**Portion 2898 & Section 3115 (92 & 102) Reichardt Road, Winnellie – Hundred of Bagot
Changes to the Development Approved by DP05/0015 to Reduce the Number of Lots from 72 to 68**

**Lots 1972 - 1977 (46 & 44) Stuart Highway, (2 & 4) Henry Street, (1 & 3) James Street, Stuart Park – Town of Darwin
New Showroom Sales Building and Associated Carparking**

site plan
SCALE 1: 200

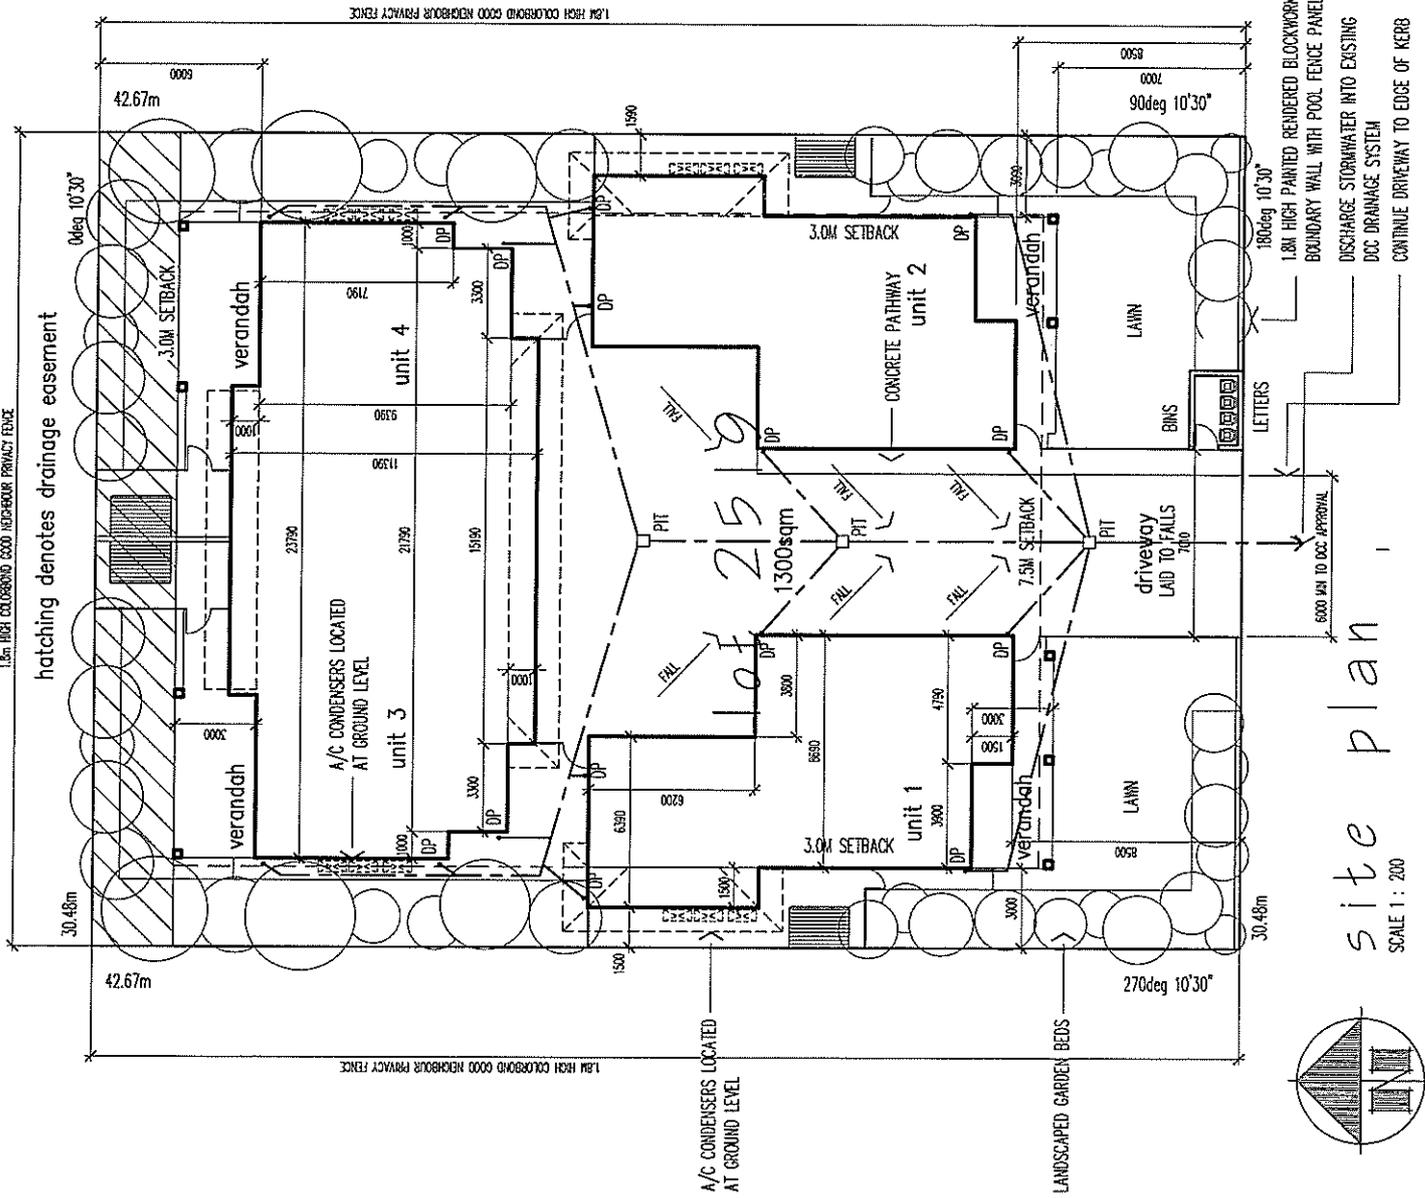
- a). The applicant's site plan demonstrates a 3-metre wide drainage easement running along the rear boundary of the site. Council has no records of any drainage easement in this location. The developer needs to establish the existence of the easement by way of a title search. The title search would also reveal in whose favour the easement has been made.
- b). **Council requests the Authority requires a stormwater drainage plan that provides the technical information required by Council to assess stormwater drainage proposals for the development.** The plan should demonstrate how stormwater will be collected on the site and connected to Council's drainage system. The plan should include details of site levels and Council's stormwater drain

connection point/s within the vicinity of the site. Council requires a stormwater drainage plan to confirm that it is technically feasible to collect stormwater on the site and dispose of it into Council's stormwater drainage system. It is also necessary to ensure that no stormwater will sheet-flow into the road reserve or onto adjoining properties. **The applicant's site drainage plan fails to provide the information required by Council at the development application stage.**

- a). **The proposed 6-metre wide crossover and driveway from Voyager Street appears to meet Council's requirements.**
- b). Council notes from the applicant's Site Plan that the waste bin enclosure and letterbox structure are proposed on the front boundary of the site, adjacent to the vehicle driveway. Council requires that a condition is placed upon any development permit to require that vehicle sight lines shall be provided at crossovers to public streets to the satisfaction of the General Manager of Infrastructure, Darwin City Council. No wall, fence or tree exceeding 0.6 metres in height shall be constructed or planted in front of the sight line. The wording of the condition is included in the list of general conditions below.

SITE PLAN

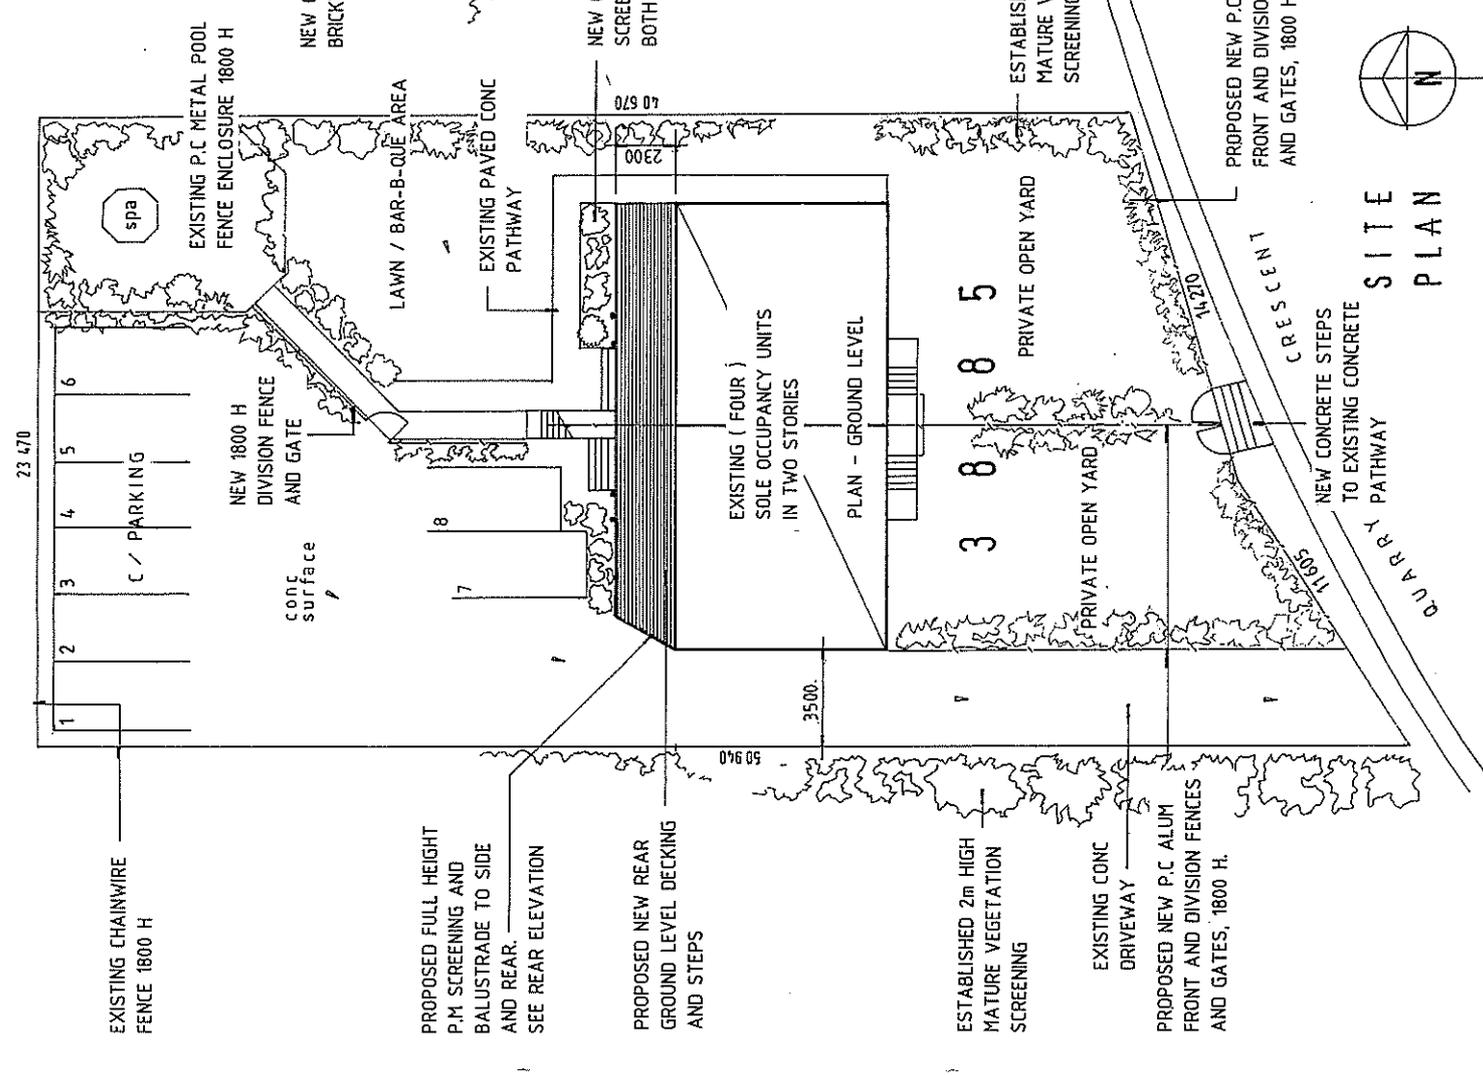
- i). **Council supports in principle the granting of a Development Permit provided the following issues are adequately addressed:**
 - a). **Council requests that the Authority requires an amended Site Plan demonstrating a waste bin enclosure designed and located in accordance with Council's Waste Bin Policy.** There is no waste bin enclosure shown on the submitted plans. A copy of Council's Waste Bin Policy can be sighted on Council's website at www.darwin.nt.gov.au.
 - 1). Unless private collection arrangements have been approved by Council, this property will be serviced by Council's manual waste bin collection service. The waste contractor enters the property on foot and wheels the bins to the garbage truck and

- b). **Council requires that a condition is placed upon any development permit issued to require that driver sight lines shall be provided at crossovers to public streets to the satisfaction of the General Manager of Infrastructure, Darwin City Council.** No wall, fence or tree exceeding 0.6 metres in height should obscure the sight line for drivers entering and exiting the property. Council notes from the development application plans that there is 'mature vegetation screening' adjacent to the vehicle driveway at its boundary with the Quarry Crescent road verge.

- a). **The development application plans do not demonstrate any proposed changes to the existing vehicle access arrangements or stormwater drainage systems on the site.**

GROUND / SITE PLAN
 1:200

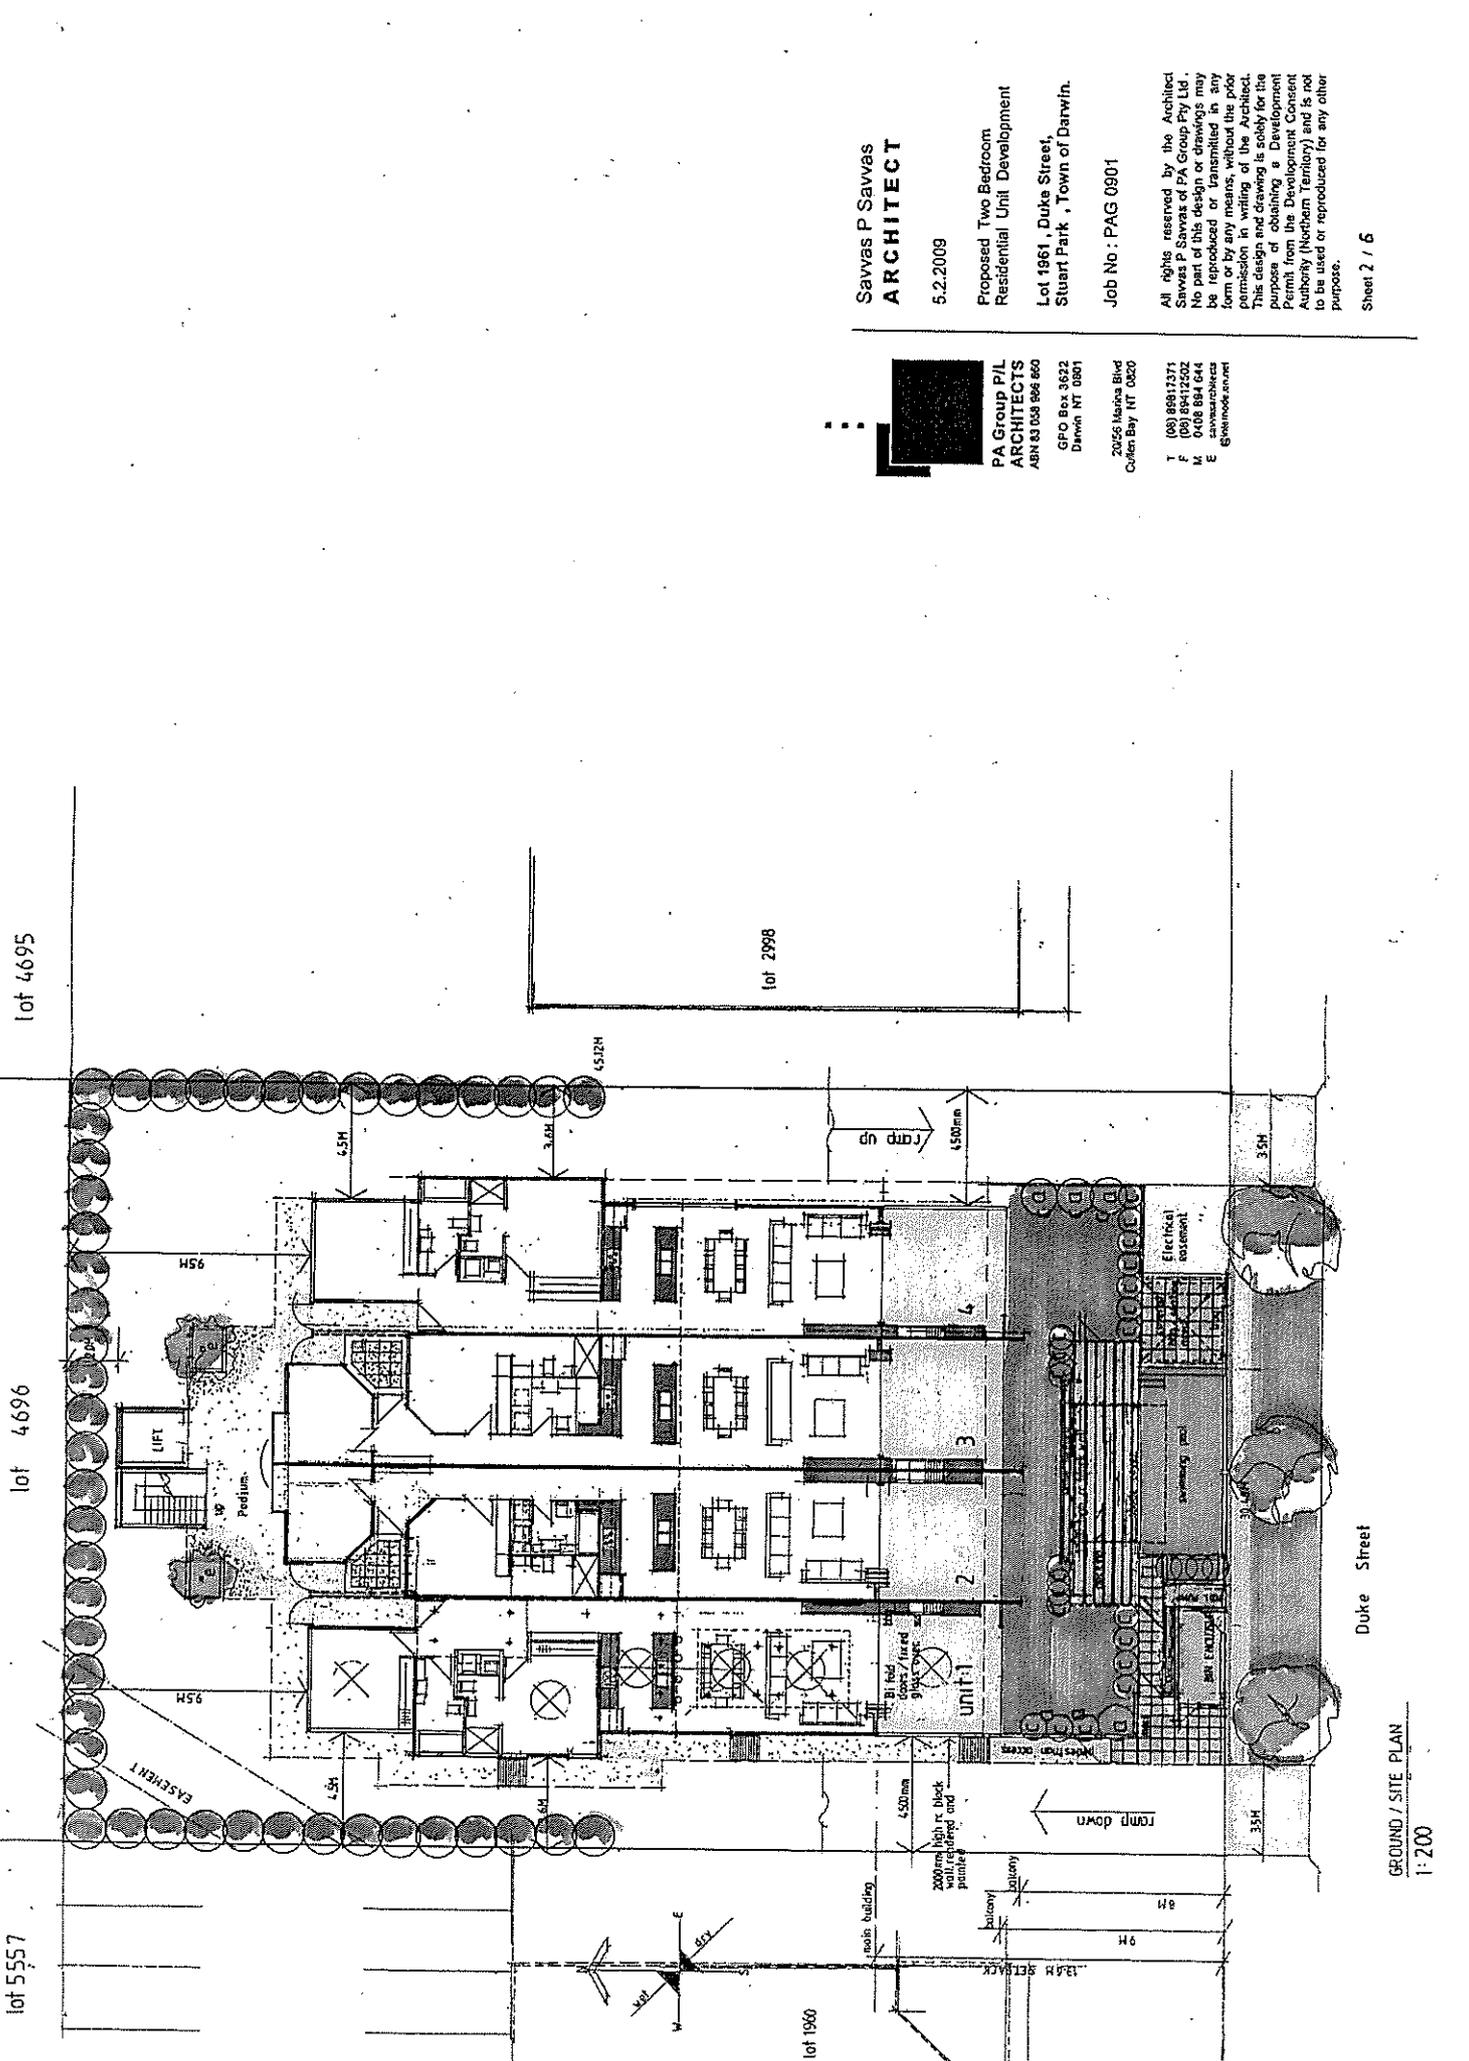
- a). **Council requests the Authority requires a schematic plan demonstrating how stormwater will be collected on the site and discharged underground to Council's stormwater drainage system.** The applicant's plans fail to demonstrate how on-site stormwater will be collected and discharged underground to Council's drainage network.
 - 1). Due to the slope of the land towards the north-eastern boundary of the site, the major drainage discharge can only outfall towards Gothenburg Crescent across Lots 4695 and 4696. An agreement with the owners of these allotments will need to be

- 3). The stormwater drainage plans should include details of site levels and Council's stormwater drain connection point/s.
- b). **Council requests the Authority requires amended plans demonstrating a waste bin storage enclosure designed in accordance with Council's requirements.** A waste bin storage enclosure is shown adjacent to the front boundary of the site, but it is not large enough to store 7 x 240 litre garbage and recycling bins, as required by Council. The waste bin enclosure is approximately 4 metres long and 1.6 metres deep and would store 5 x 240 litre bins only. Council's Waste Bin Policy requires the developer to provide an enclosure to store 7 x 240 litre bins (4 for general garbage and 3 for recycling). A 240 litre bin has a depth of approximately 80cm and a width of approximately 60 cm. There should be a 1 metre corridor available within the bin storage area for the waste service contractor and residents to access the bins.

- c). **Council requests the Authority requires amended plans demonstrating driver sightlines at the crossover from the car park exit to the Duke Street verge that meet Council's requirements.** No wall, fence or tree exceeding 0.6 metres in height should be constructed or planted in front of the driver sightline to protect the safety of pedestrians using Duke Street.

- d). **Council raises no objection, in principle, to the proposed 2 x 3.5 metre crossovers and driveways.**
- 1). Council has noted that the driveway gradient shown differs on the site / basement floor plan and the section A-A plan. The gradient shown on the site / basement floor plan is 1:55 maximum and on the section A-A plan is 1:8. The car park driveway ramps should not have a gradient in excess of 1:8, in accordance with AS 2890.1.2004.

The submitted plans include a 0.8 metre wide footpath, lawn areas and trees within Council's Duke Street road reserve.

SECTION A

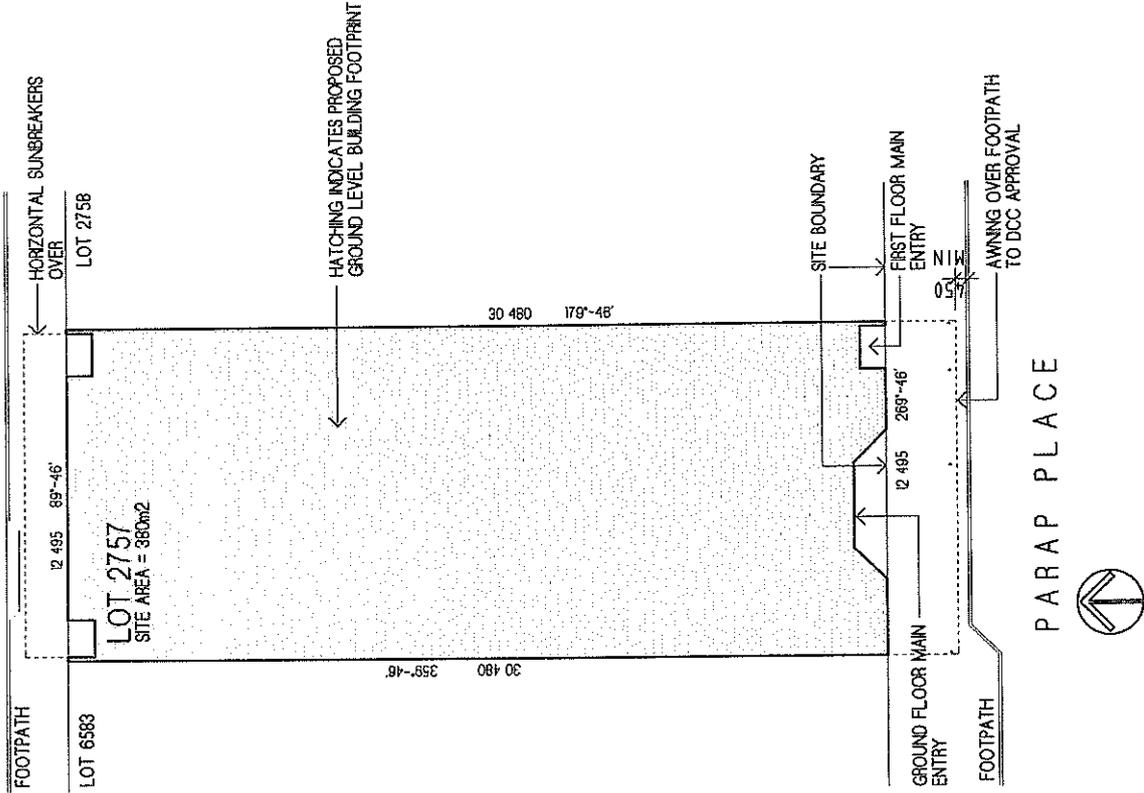
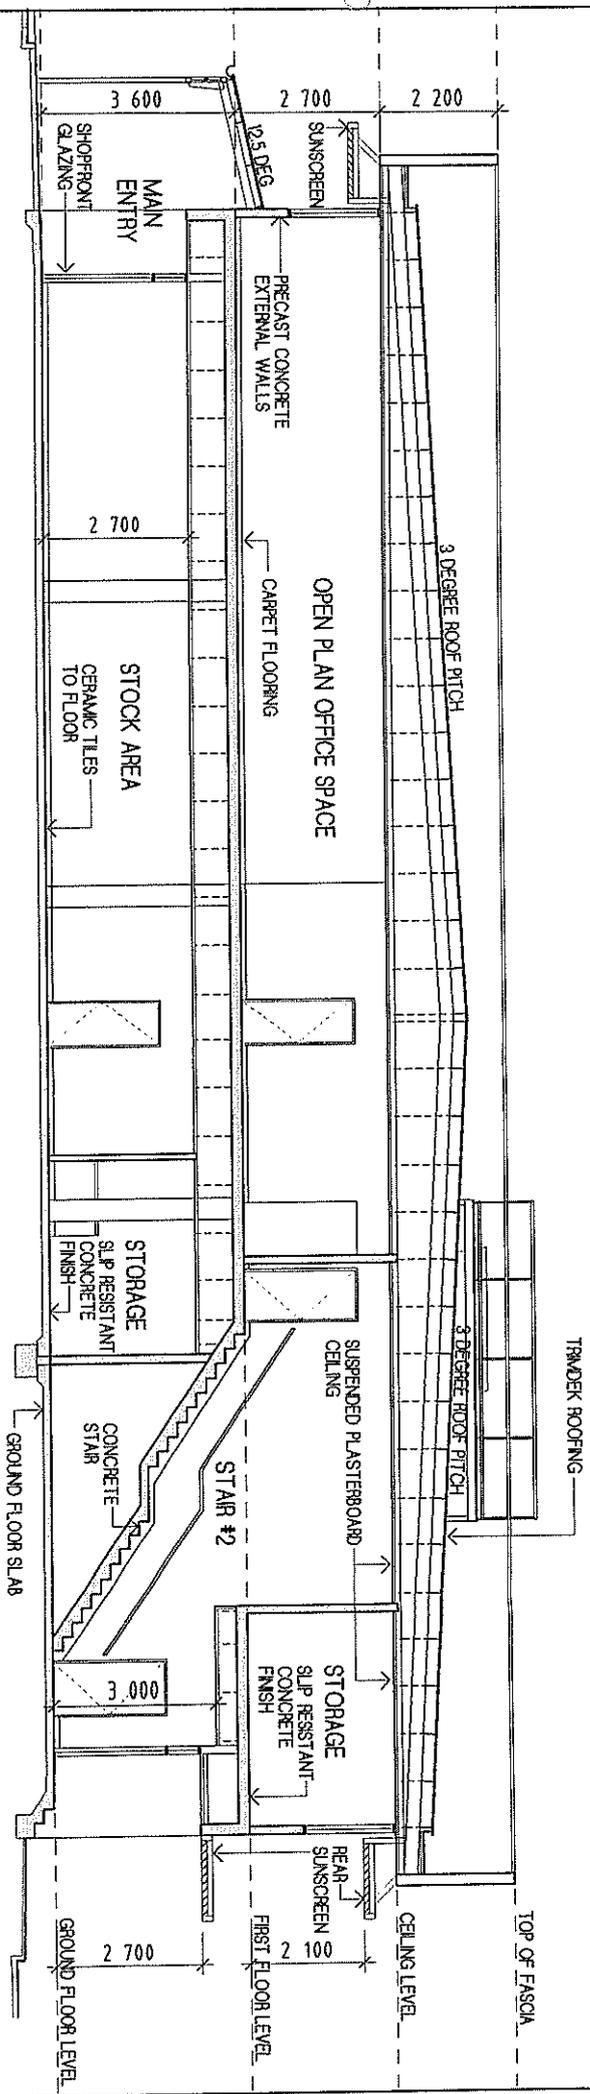
- 2). The development proposal generates a car parking requirement of 15 spaces (based upon the applicant's assessment on pages 2 & 3 of the development application submission) and no spaces are provided. Council agrees with the applicant's car parking calculations assuming that the 'stock' area shown on the plans is correctly defined as showroom sales rather than retail floor-space. A definition of retail floor-space would generate a requirement for 3 more car parking spaces, taking the total to 18.
- 3). The applicant (page 3 of submission) has acknowledged the requirement to pay a developer contribution for the car parking shortfall. Council will not support waivers to the car parking requirements for new developments, due the high demand for car parking within Parap Village.

- 1). **The 'feature high level fin' that is attached to the Parap Place building façade and extends from first floor level to above roof level.** The fin is approximately 5 metres high and the top of the fin is 9.5 metres above the footpath level of Parap Place. The fin is triangular in shape and at its widest point extends approximately 2.4 metres over the Parap Place road reserve. The fin is included on the First Floor Plan, the Roof Plan and the Elevation Plans.

- 2). **The roof of the building and the attached wrap around 'aluminium fascias' on both the Parap Place and Urquhart Street frontages of the building.** The development application plans indicate that the aluminium fascias are 2.2 metres in height and will project over Council's road reserve by approximately 1 metre across both the Parap Place and Urquhart Street road reserves. The roof and the fascias are included on the First Floor Plan, the Roof Plan, the Elevation Plans and the Section Plans. The top of the fascia on Urquhart Street is at a height of 9.05 metres above the Urquhart Street footpath.

- 3). **The first floor 'horizontal sun breakers' projecting approximately 1.5 metres across the Parap Place road reserve and the Urquhart Street road reserve.** The sun breakers are shown on the Ground Floor Plan, First Floor Plan, Roof Plan, the Elevation Plans and the Section Plans.

The development application plans also demonstrate an approximate 2.5 metre wide awning over the Parap Place footpath and an approximate 1.5 metre wide horizontal sun breaker across the Urquhart Street footpath.

- a). The height of the proposed development exceeds the maximum building height of 8.5 metres, as set out under Clause 6.1 of the Planning Scheme. The height of the Urquhart Street façade of the building is approximately 9 metres, and the height of the ‘feature high level fin’ on the Parap Place façade is approximately 9.5 metres. The roof plant deck enclosure is also at a height greater than 8.5 metres.

- b). The plot ratio of the proposed building is over 2 times greater than that permitted under Clause 6.4 of the Planning Scheme. Clause 6.4 states that developments of sites within zone C (Commercial) should not exceed a plot ratio of 1. The plot ratio of the proposed building is 2.04 (as set out by the applicant on page 1 of the planning submission and the Site Plan).
